Subject: NHTSA Campaign Number 13V-341/Jaguar Safety Recall J034 – XF Charge Air Cooler Hose - Dealer Communication

J034NAS1

Safety Recall: Engine Charge Air Cooler Hose Detachment

E159753

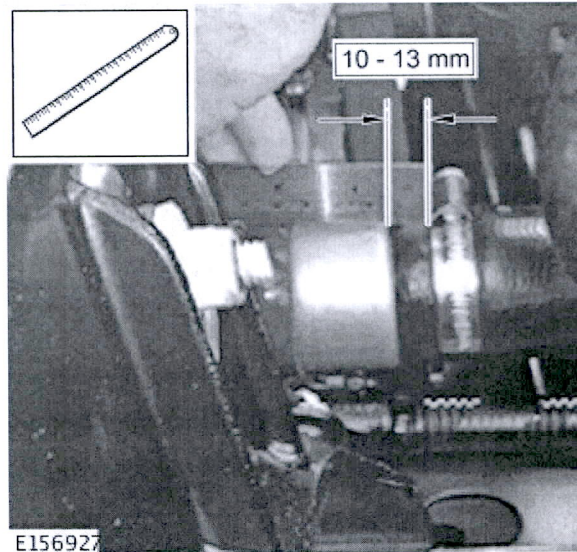
3. Check position of the charge air cooler hose clip.

- If: the clip is less than 10mm from the resonator; a gap exists between the resonator and the end of the hose; or the clip is not positioned squarely on the hose, carry on from step 4.
- If: the clip is between 10mm and 13mm from the edge of the resonator; and the hose is butted against the resonator, carry on from step 5.

4. Reposition hose correctly on the resonator and position the clip 13mm from the edge of the resonator.
5. Tighten the clip to 6Nm, ensuring the clip remains in position and square to the edge of the resonator.
6. Close hood.
